Harris Nuclear Plant Pre-Submittal Meeting - February 27, 2018

License Amendment Request for
Emergency Plan Emergency Action Level
Scheme Changes

III. Cold Shutdown Radiation Monitor Threshold

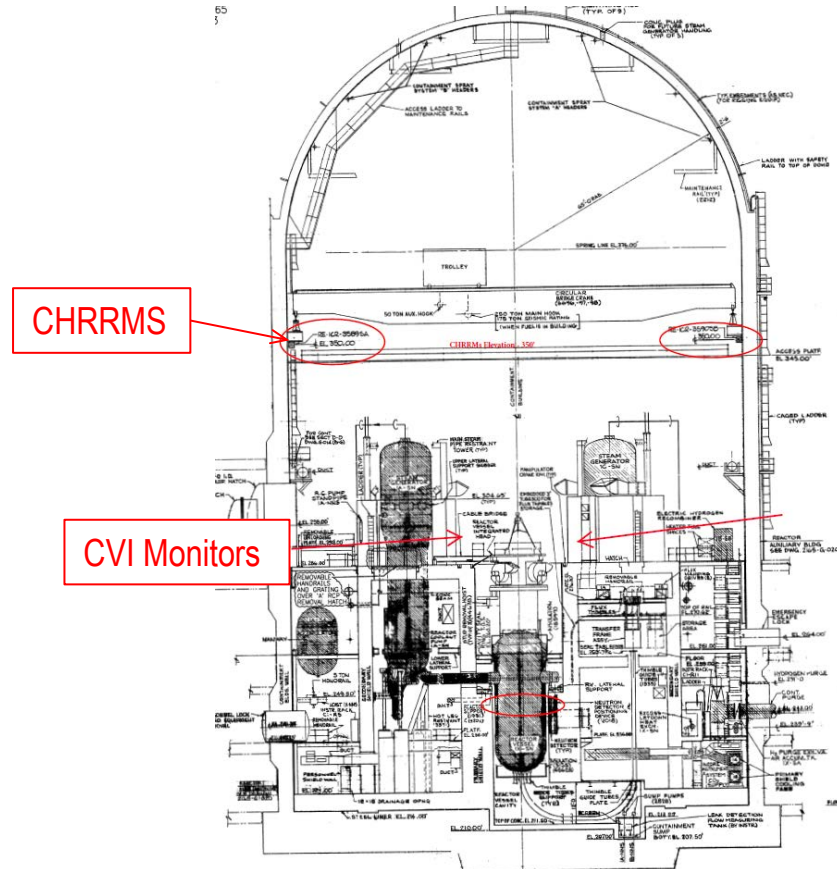
Current: 'CG1.2' and 'CS1.3' utilize CNMT radiation levels at the CHRRMs

Proposed: Utilize Containment Ventilation Isolation (CVI) radiation monitors high alarm

CVIs offer several advantages over CHRRMs for use in EALs CS1.3 and CG1.2:

- Better low range sensitivity
- Greater number of monitors
- Closer to the core

<p>A CVI monitor in high alarm (RM-1CR-3561A-SA, RM-1CR-3561B-SB, RM-1CR-3561C-SA, or RM-1CR-3561D-SB)</p>
